*ADMINISTRATIVE DESIGN REVIEW
RECOMMENDATION MEETING*
#3026926
1501 NW 59th St

SITE ADDRESS 1501 NW 59th St
 PARCEL NUMBER 2767604525
 SDCI # 3026926
 APPLICANT Neiman Taber Architects
 1421 34th Avenue, Suite 100
 Seattle, WA 98122
 (206) 760-5550
 CONTACT David Neiman
 dn@neimantaber.com
 ZONING NC3-40
 OVERLAYS Ballard Hub Urban Village
 LOT SIZE 5,000 SF
 ALLOWABLE FAR 3.25 (GFA: 16,250 SF)
 PROPOSED UNITS 52
 PROPOSED PARKING 0
 FREQUENT TRANSIT Yes

SDCI STAFF RECOMMENDATIONS + SUMMARY RESPONSE

PERSPECTIVE: SETBACK DEPARTURE

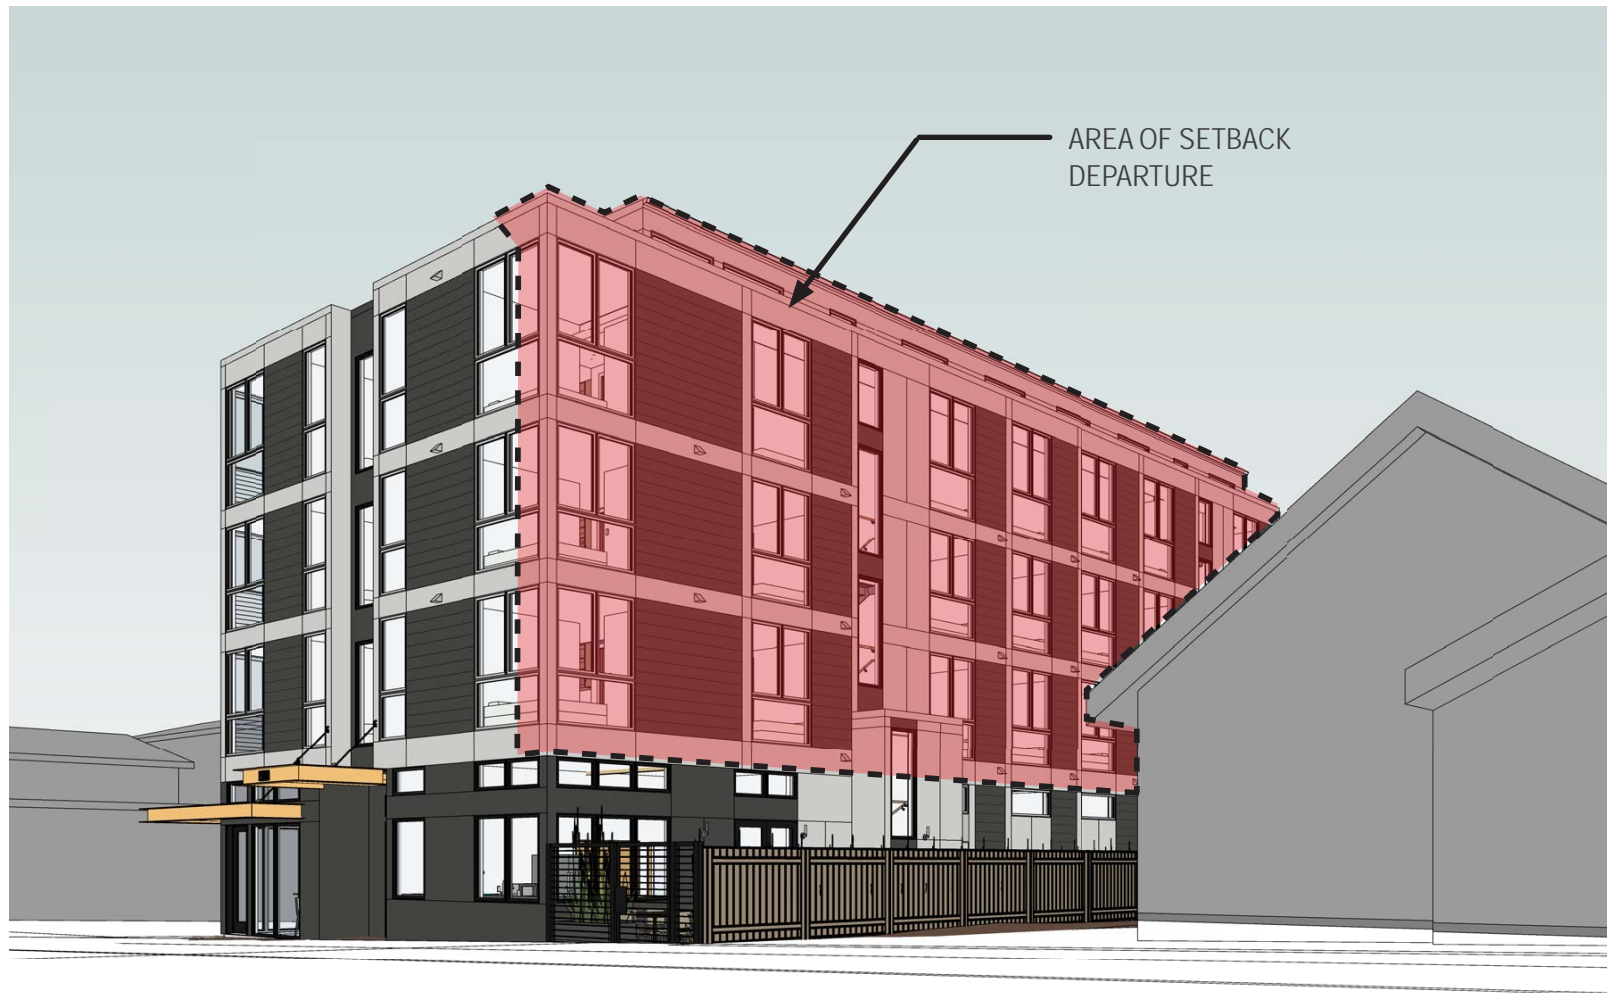
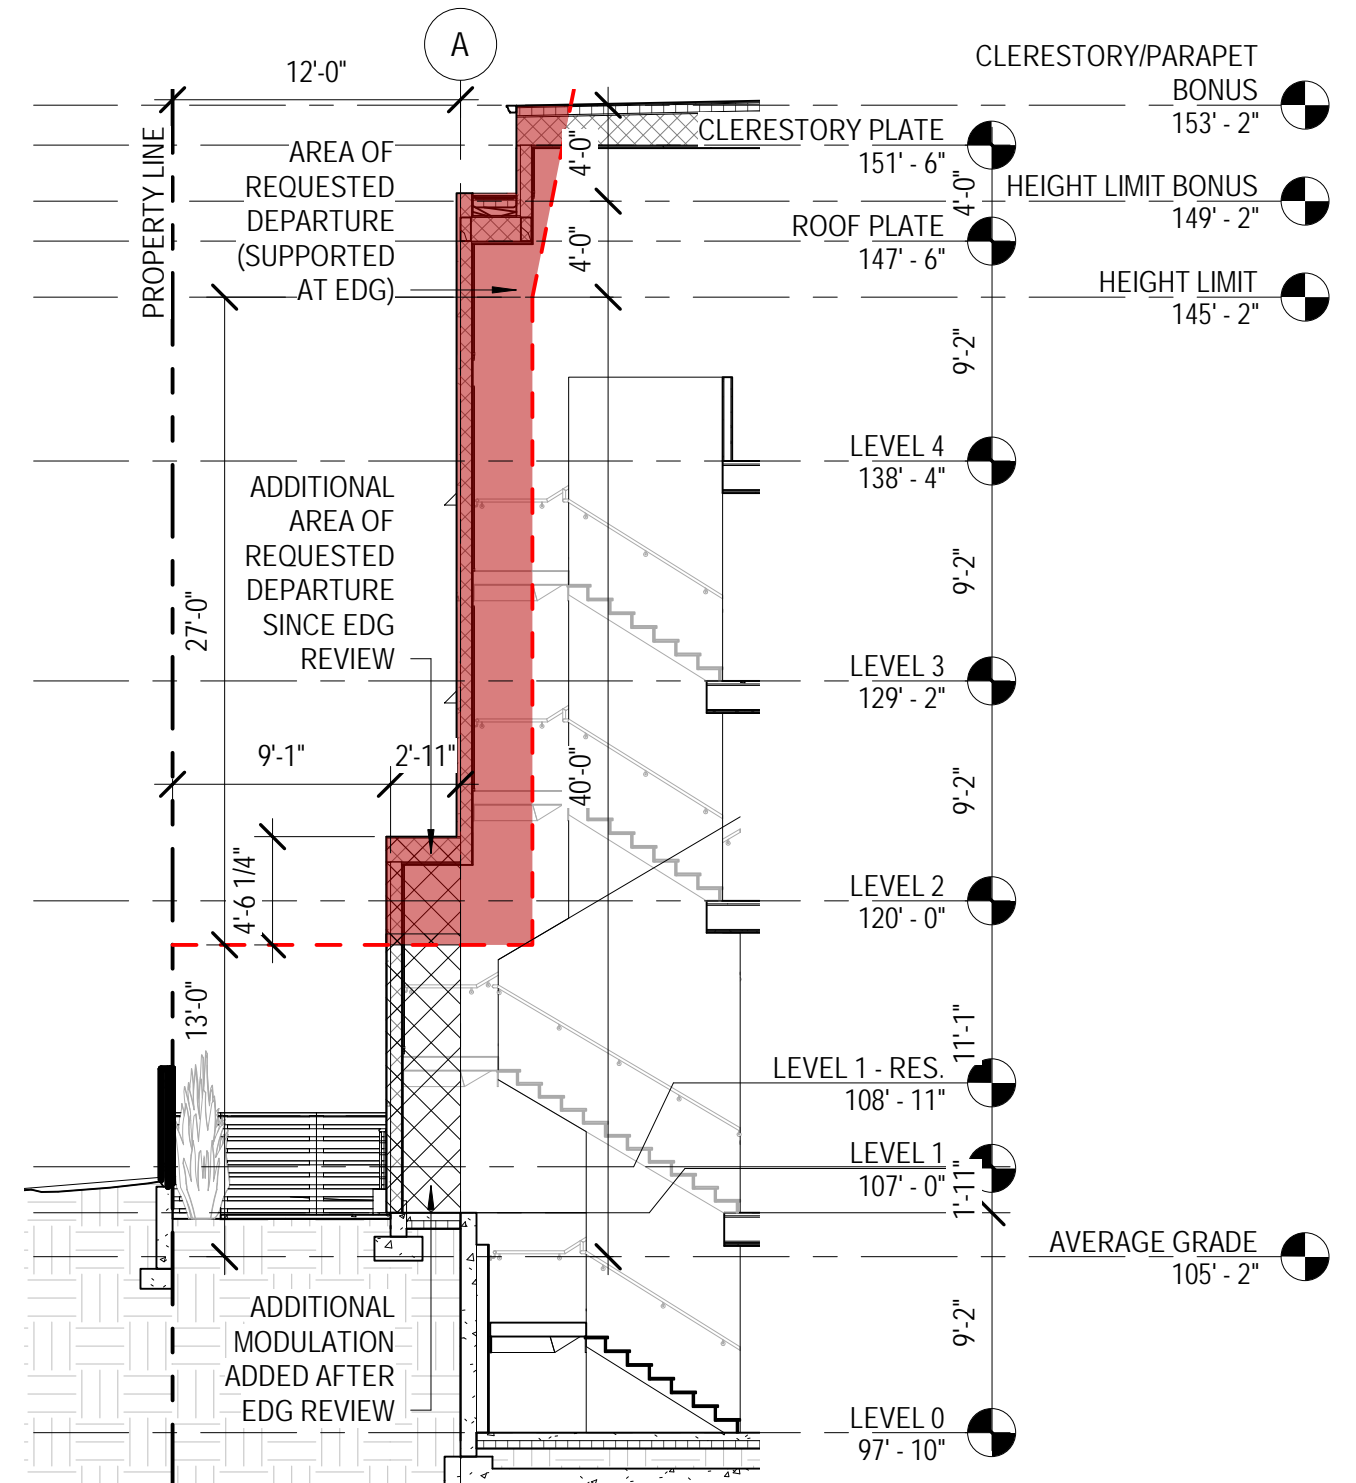
STAFF RECOMENDATION: Staff indicated preliminary support for this departure as the setback on the ground floor provides opportunity to buffer the structure from the adjacent properties, meeting the intent of the setback requirement. Staff recommends including vegetation that is vertical in nature in the design of the common amenity area to strengthen that buffer and help minimize any privacy issues. (PL3-B-1. Security and Privacy, DC4-D-1. Choice of Plant Materials)

DESIGN RESPONSE: Vegetation that is Vertical in nature has been added along the western property line as requested: Buxus sempervirens 'Green Tower' / Green Tower Boxwood, ~ 9' tall at maturity. The planting extends from the bioretention planter to the south to the north property line.

PLAN: CURRENT PROPOSAL

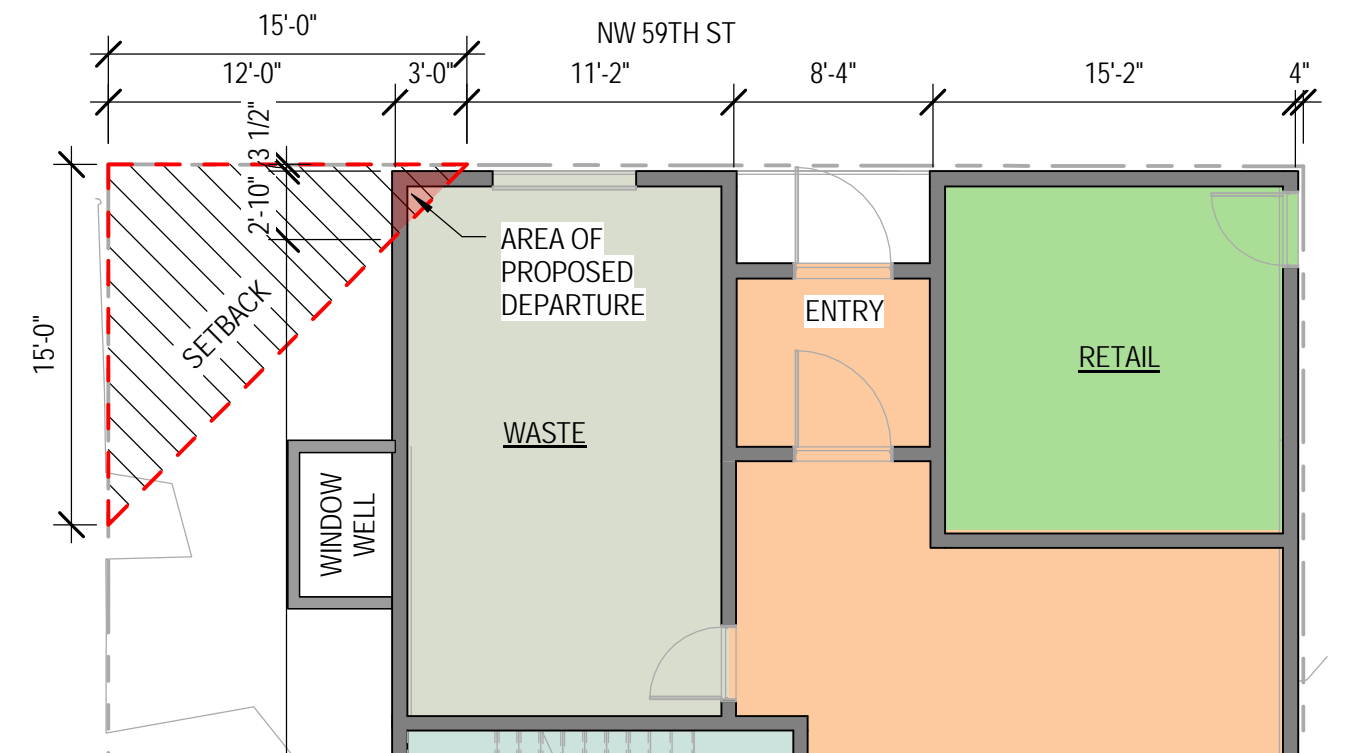
STAFF RECOMMENDATION: Staff indicated concern with this departure as proposed and believes rearranging the ground level uses and primary residential entry as a response to the design guidance provided will eliminate the need for this departure and maintain the zone transition intended by this set back standard. (DC1-A. Arrangement of Interior Uses)

DESIGN RESPONSE: In response to feedback from SDCI staff the northwest corner of the building and the entry has been reconfigured to provide a more active facade along NW 59th ST. The changes have not eliminated the need for this departure and has in fact increased the justification for it.

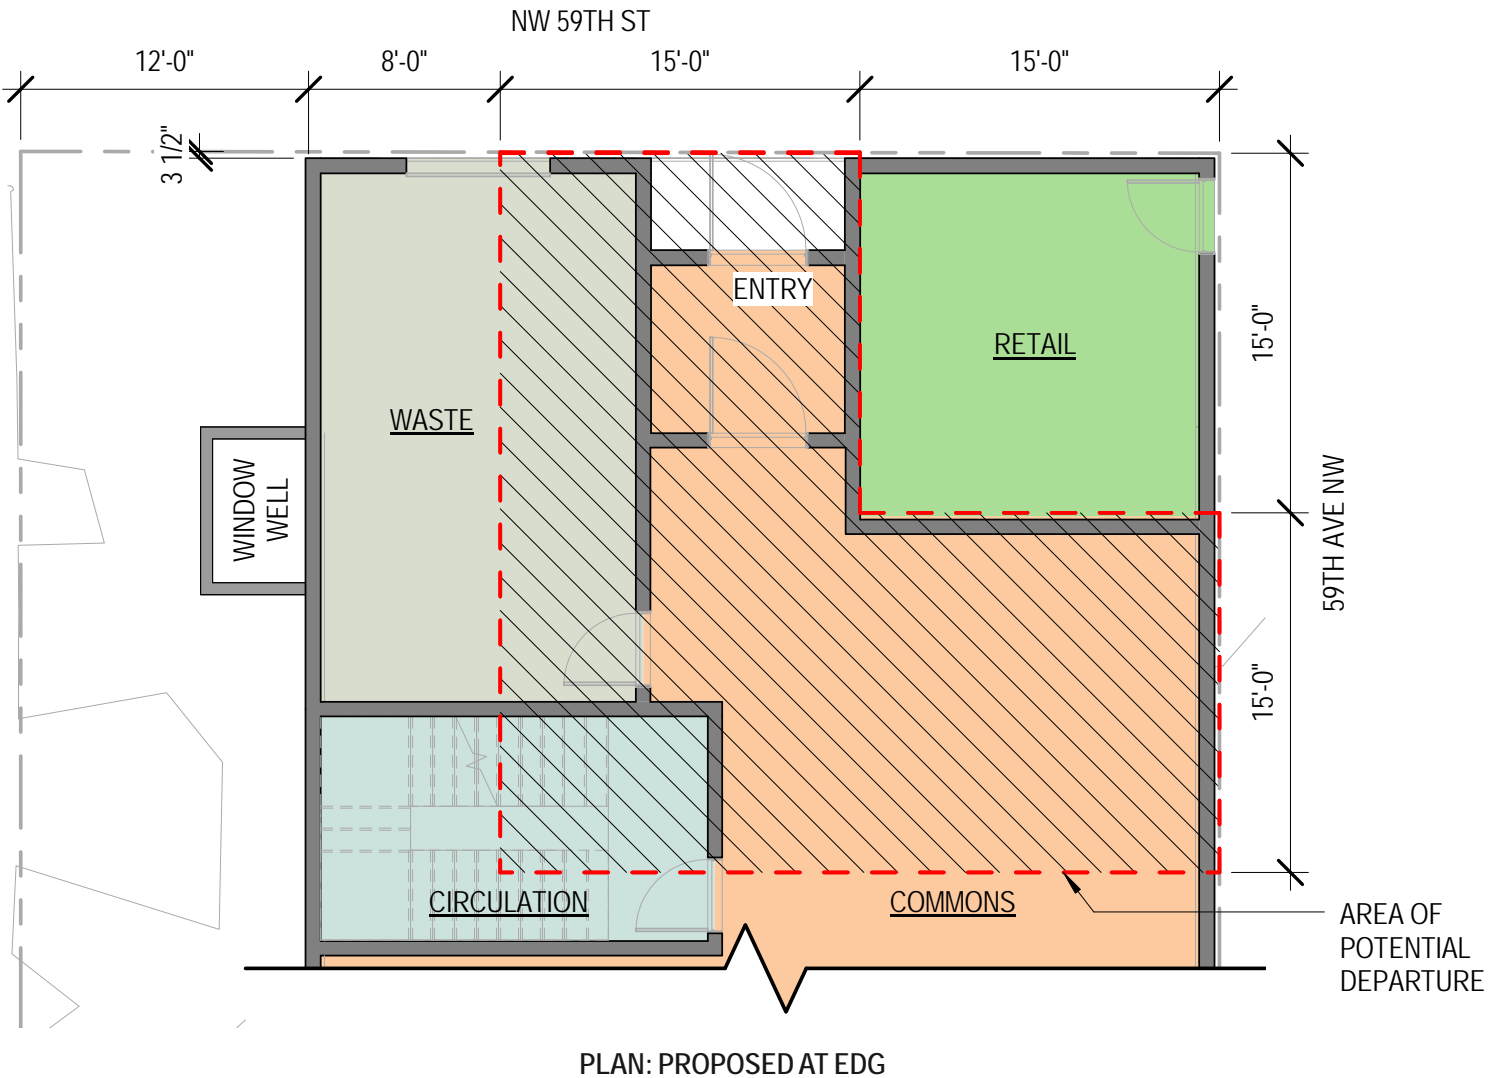
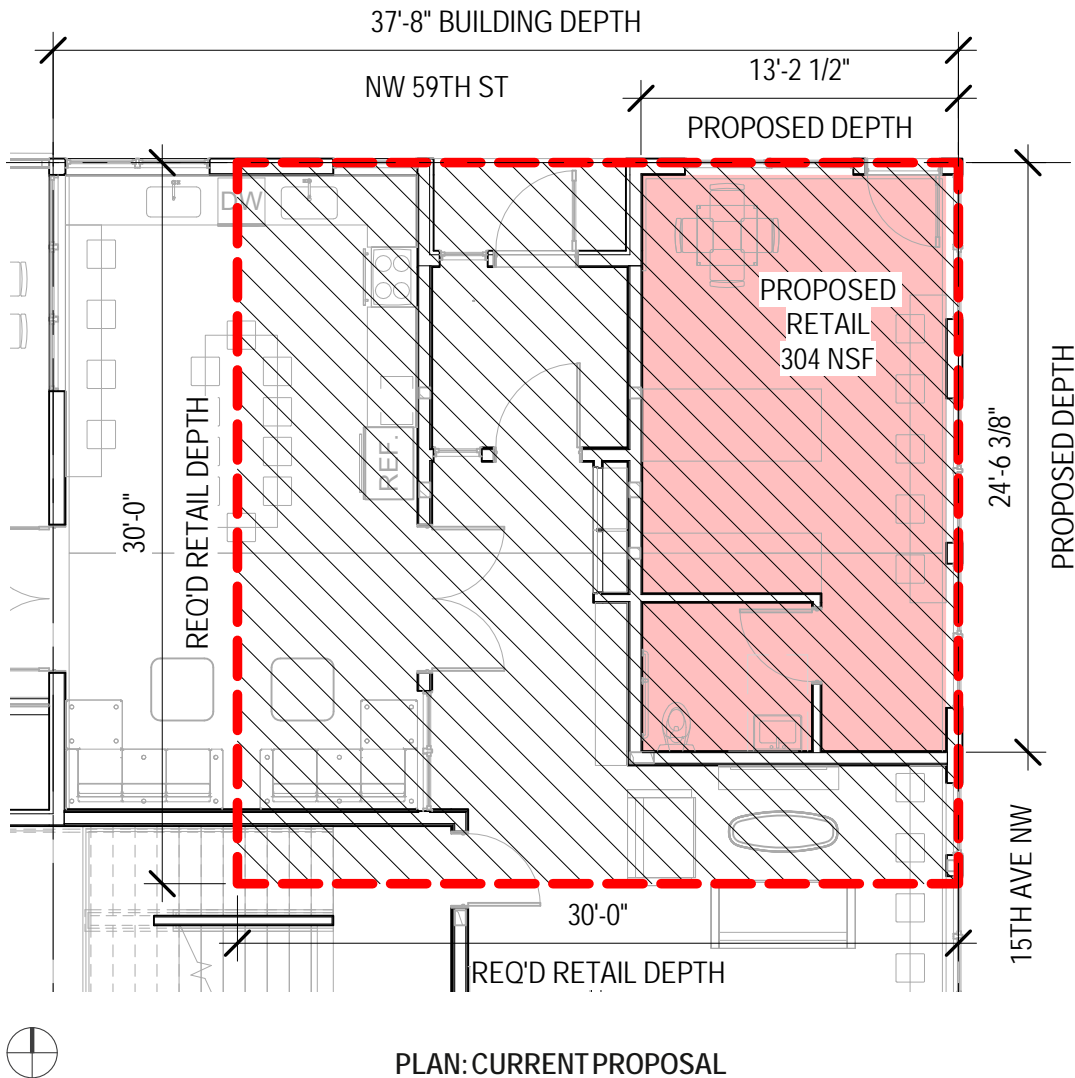
STAFF RECOMMENDATION: Staff indicated preliminary support for this departure contingent upon additional information showing a potential layout of the commercial space to demonstrate how it can successfully accommodate a usable retail use. (DC1-A. Arrangement of Interior Uses)

DESIGN RESPONSE: The retail area has been increased from ~225 NSF to ~304 NSF and a possible layout of the commercial space added to demonstrate viability as requested.

ELEVATION: STREET FACING, STREET LEVEL RESIDENTIAL UNITS ALONG 15TH AVE NW

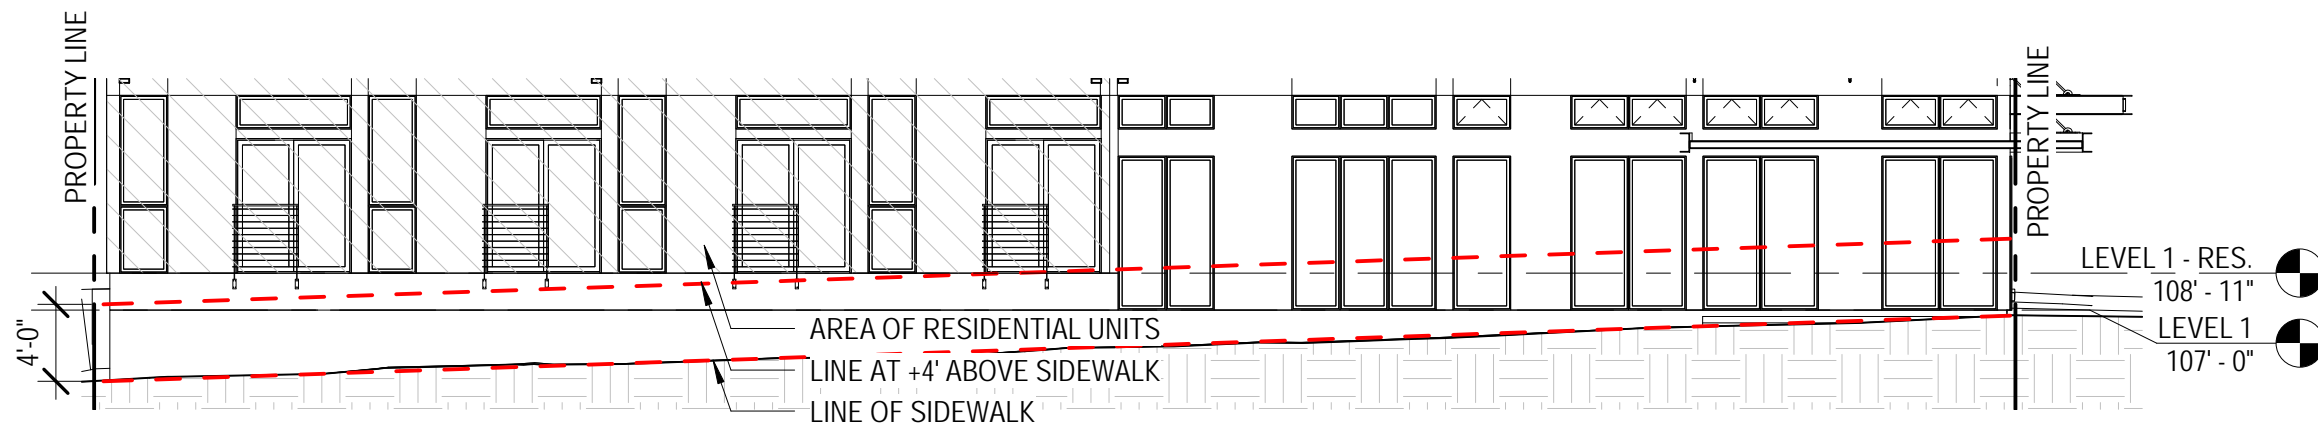
STAFF RECOMMENDATION: Staff indicated concern with this departure as proposed and believes rearranging the ground level uses and primary residential entry as a response to the design guidance provided will eliminate the need for this departure and maintain the zone transition intended by this set back standard. (DC1-A. Arrangement of Interior Uses)

DESIGN RESPONSE: The requested departure has been removed. The residential floor level has been adjusted so that all street facing unit floors are now 4' or more above sidewalk grade
